Response to London Borough of Camden Sustainability and Energy comments

13 Blackburn Road

Project No: 55186

This note has been prepared in response to comments received 18/01/2021 from the London Borough of Camden on the Sustainability and Energy Statements prepared in support of the Clockwork Factory (2020/2940/P) planning submission and related to the proposed sustainability and energy strategy of the development.

Figure 1 – Proposed route for the future pipework

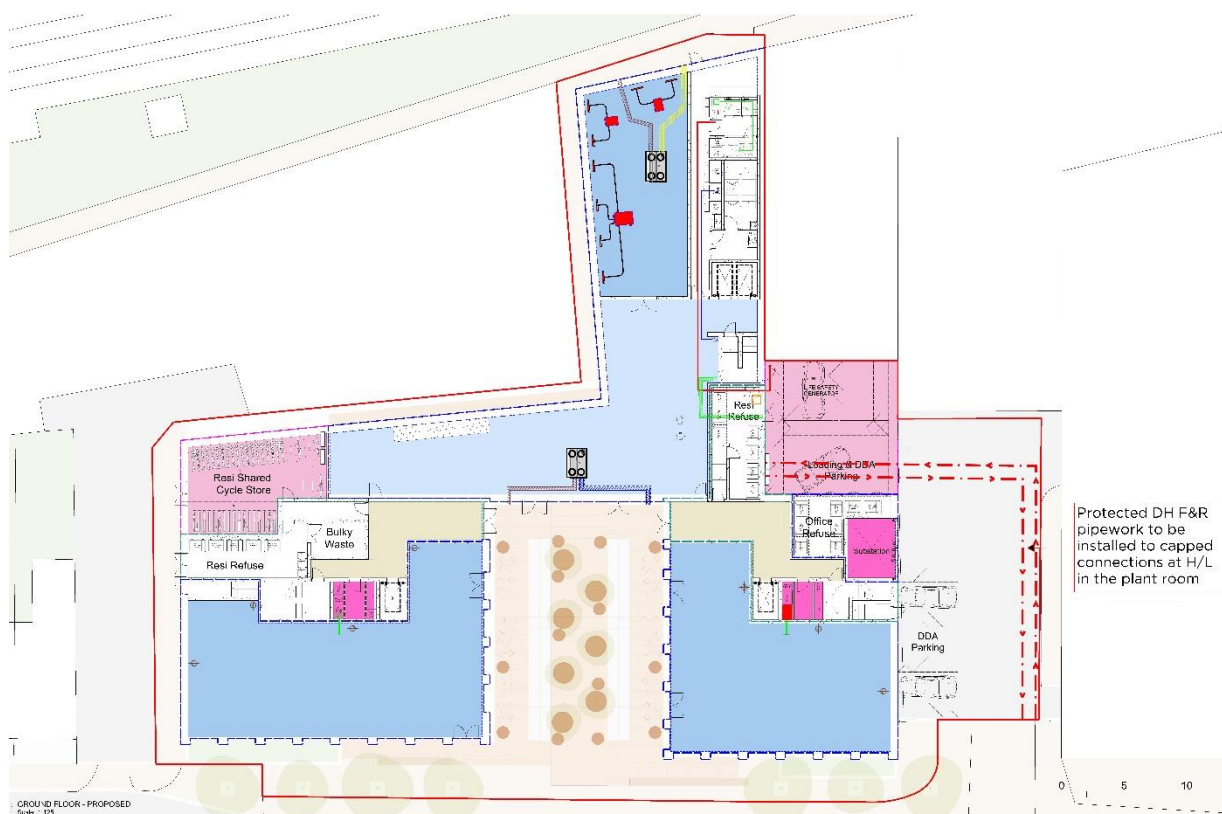
Comment: Please include proposals to protect the future pipework routes from the basement plant room to the boundary (at likely incoming DEN connection points): street side and O2 centre side.

A proposed route for the future pipework from the basement plant room to the boundary to facilitate a future connection to the Finchley Road 'O2 Centre' extended plot that has potential as a major DEN is presented in the ground floor plan below.

Figure 2 – Typical details provided by a specialist showing a blue roof build-up with extensive green roof

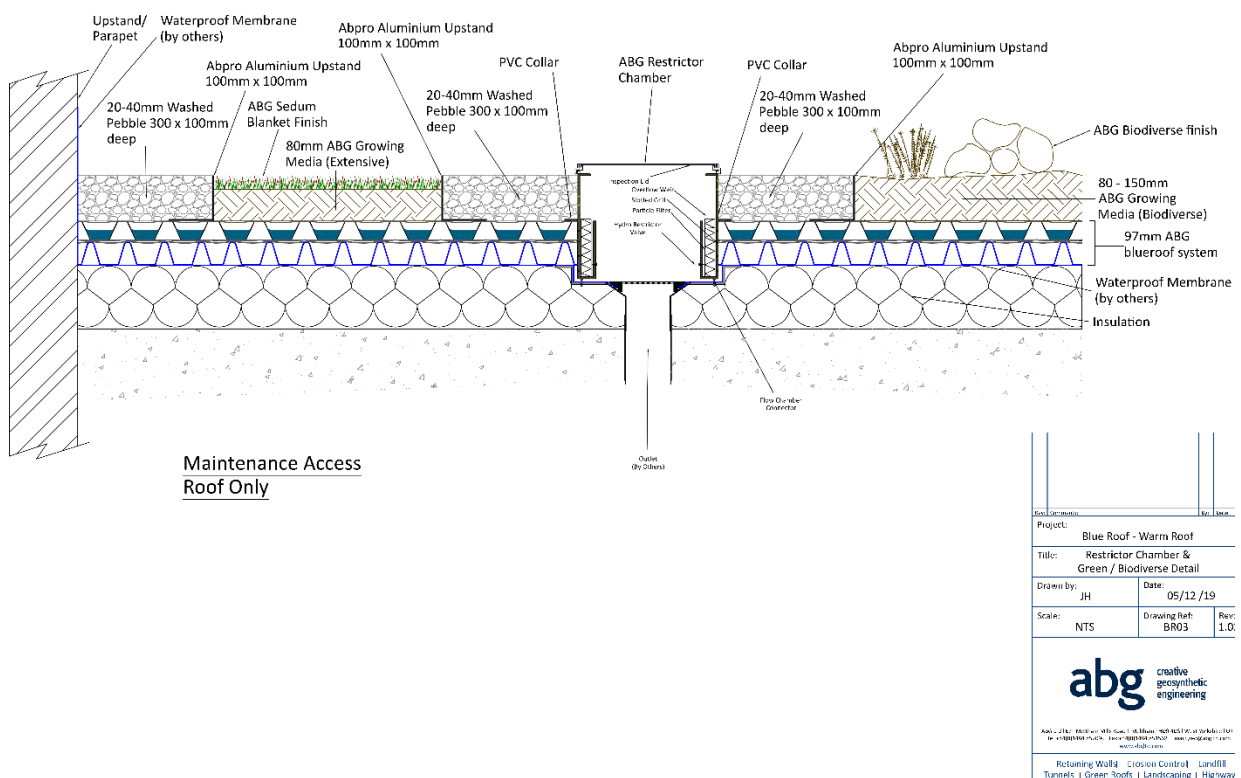
Comment: It should be confirmed that the green roofs will be fully integrated with blue roofs and of the intensive type wherever technically feasible, with minimum 150mm soil depth, as policies ask.

The scheme proposes blue/green roofs atop the development, which will be biodiverse, low fertility, and low maintenance. These will be designed in detail at the next stage of the design – see next two figures for location, areas and typical details.
